Re: O3b Limited Response to Commission Questions
IBFS File No. SAT-AMD-20161115-00116 (Call Sign S2935)

O3b Limited (“O3b”) hereby provides the following supplemental information in response to the letter dated March 21, 2017,¹ regarding the above-referenced O3b application.² The text of the questions in the Commission Letter is provided below (with footnotes omitted), followed by O3b’s response for each question.

Annex 1 EPFD ↑ and EPFD(is) output plots using ITU EPFD validation software

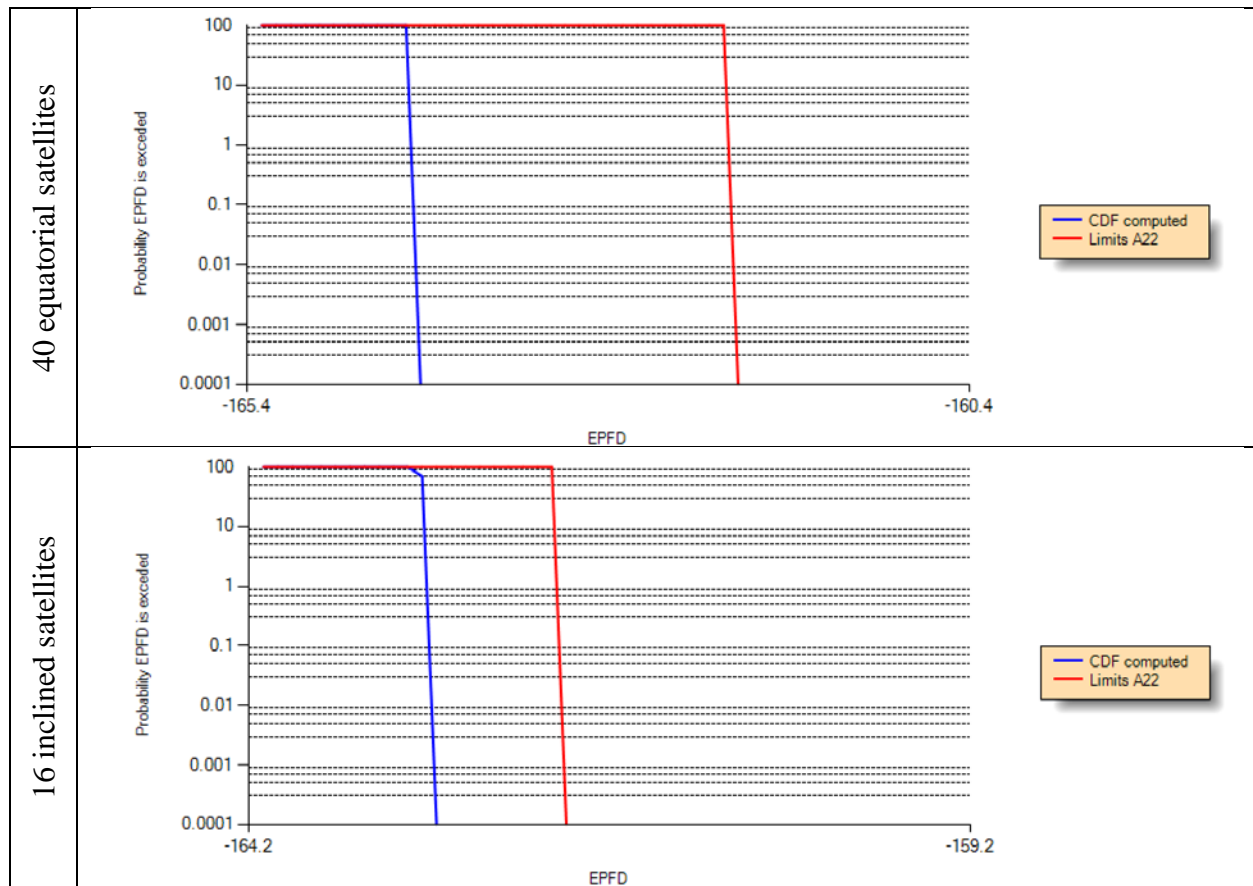
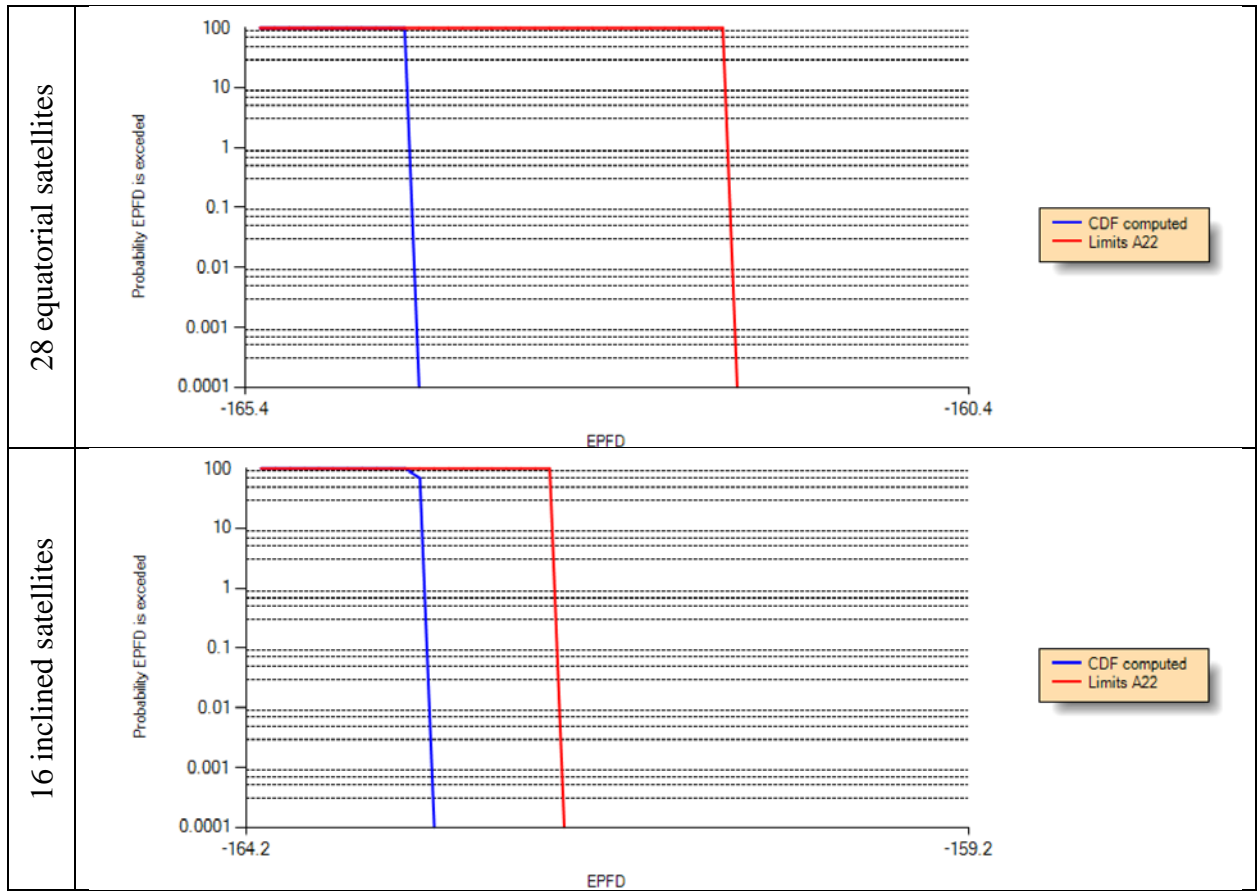
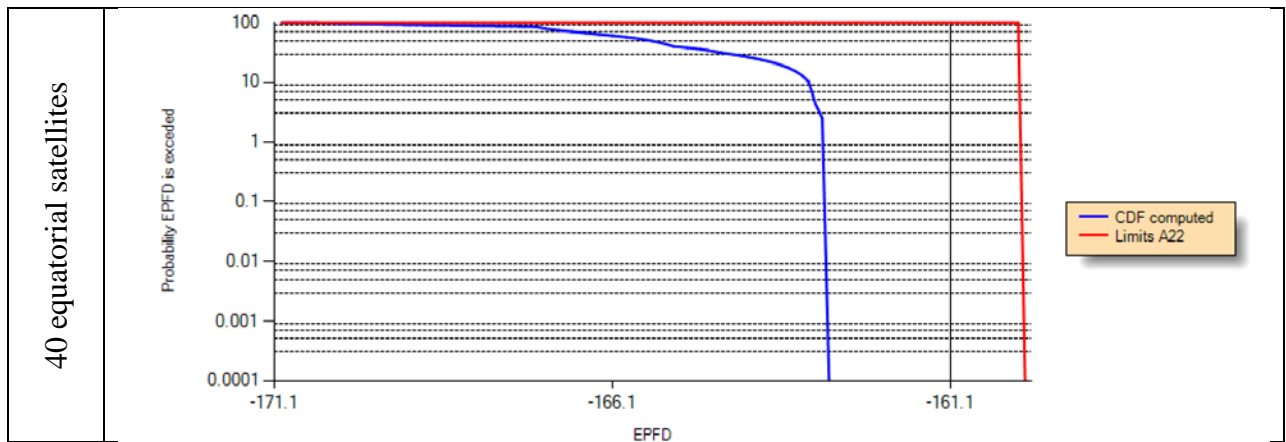
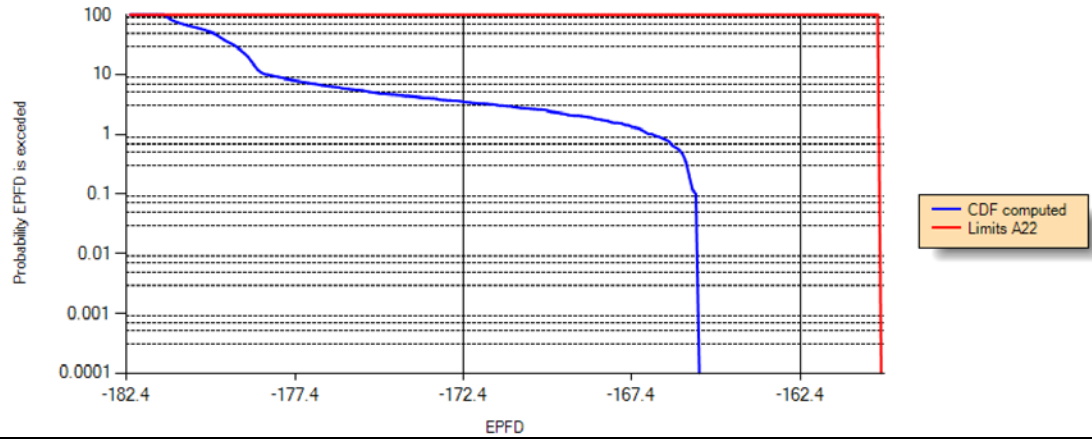
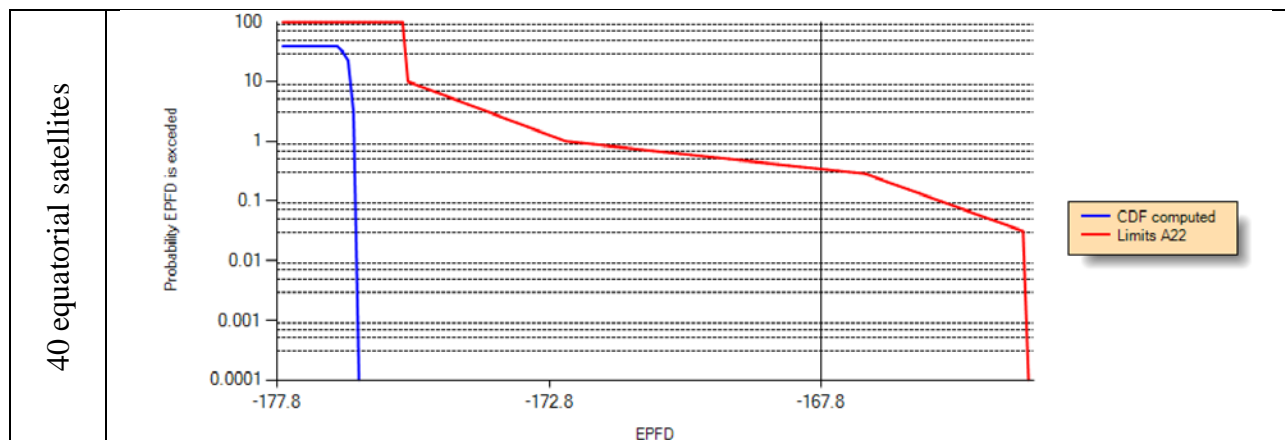
3. Article 22.5I of the ITU Radio Regulations requires NGSO networks to meet the equivalent power flux density (EPFD) limits specified in Articles 22.5C (EPFD ↓), 22.5D (EPFD ↑), and 22.5F (EPFD_{is}) for an NGSO system to fulfill its obligations with respect to geostationary satellite orbit (GSO) networks under Article 22.2. O3b provides, in its interference analysis, a narrative showing that it complies with Articles 22.5C (for the 17.8-18.6 GHz and 19.7-20.2 GHz frequency bands), 22.5D (for the 27.5-28.6 GHz and 29.5-30 GHz frequency bands) and Article 22.5F (for the 17.8-18.4 GHz frequency band). We request that O3b submit, for all these frequency bands, a complete set of PFD masks on the surface of the Earth for each of the 56 active space stations in its NGSO FSS system, and a complete set of NGSO FSS earth station EIRP masks as a function of the off-axis angle generated by the NGSO FSS earth station, which are required to run the ITU-R Recommendation S.1503 EPFD Validation Software. Please also supplement the amendment to include the output data files from the ITU EPFD Validation Software, and/or corresponding plots of the computed EPFD levels for the 56 active satellite constellation compared to the EPFD masks for each of the reference GSO and/or BSS earth station antennas.

As noted in our Extension Letter, O3b evaluated compliance with the EPFD ↓ limits in Article 22 of the ITU Radio Regulations with the O3b proprietary software used to manage and operate the O3b constellation. O3b evaluated the EPFD ↑ and EPFD_{is} levels using the ITU software. However, the current implementation of the ITU software does not properly model the O3b satellite system as further described in Annex 1 and Annex 2 attached.

Annex 1 shows the calculation output for the EPFD \uparrow and EPFD_{is} levels using the ITU EPFD Validation software.

The EPFD ↑ and EPFD(is) validation results for the O3b system are shown below in Figures 1-1 through 1-3. The XML mask files and associated SRS database used to examine the masks in the ITU EPFD validation software are attached. The validation software used was the Agenium version. The Transfinite version was not able to validate the O3b constellation due to an unknown error that occurred when trying to run the validation.
